APPLICATION NO.	FILING DATE	FIRST NAMED INVENTOR	ATTORNEY DOCKET NO.	CONFIRMATION NO.
09/851,347	05/09/2001	Mamoru Aoki	313KA/49958	3042

Office Action Summary	Application No.	Applicant(s)
	09/851,347	AOKI ET AL.
	Examiner Heba Elkassabgi	Art Unit 2834

DETAILED ACTION

F I G. 1

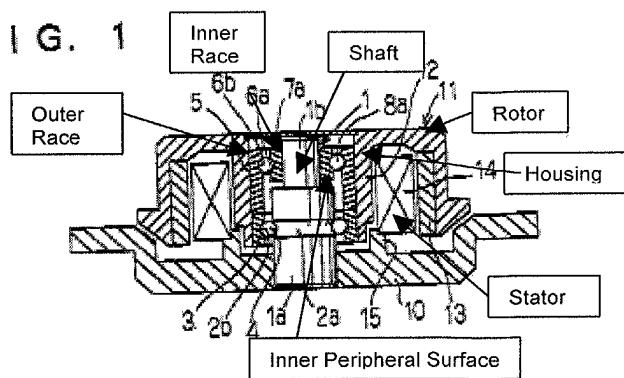
10. Obara discloses in Fig. 1 a motor in which the stator and rotor are covered by a housing, a ball bearing between the housing and shaft, an inner peripheral surface for the housing, a bearing with inner and outer race, an inner race having an inner peripheral surface, an outer race having an outer peripheral surface, the inner race being fixed to the shaft through press-fitting between the outer peripheral surface of shaft and inner peripheral surface inner race, the outer race being fixed to the housing through press-fitting between outer peripheral surface of outer race and inner peripheral surface of housing, but does not disclose a shaft with outer grooved peripheral surface.

FIG. 1

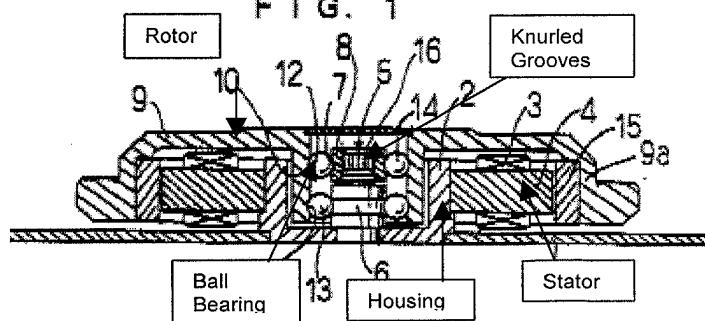
11. Yoshimura et al. discloses a shaft in Fig. 1 with an outer knurled portion of the peripheral surface in which the inner race is fixed to the shaft through one press-fit and by an adhesive between the outer peripheral surface of the shaft and the inner peripheral surface of the inner race for the purpose of lubricating the shaft.

12. It would have been obvious at the time the invention was made to a person having ordinary skill in the art to modify Obara's invention by adding an outer knurled portion of the peripheral surface of the shaft for the purpose of an efficient lubrication within the shaft as commonly known in the art.
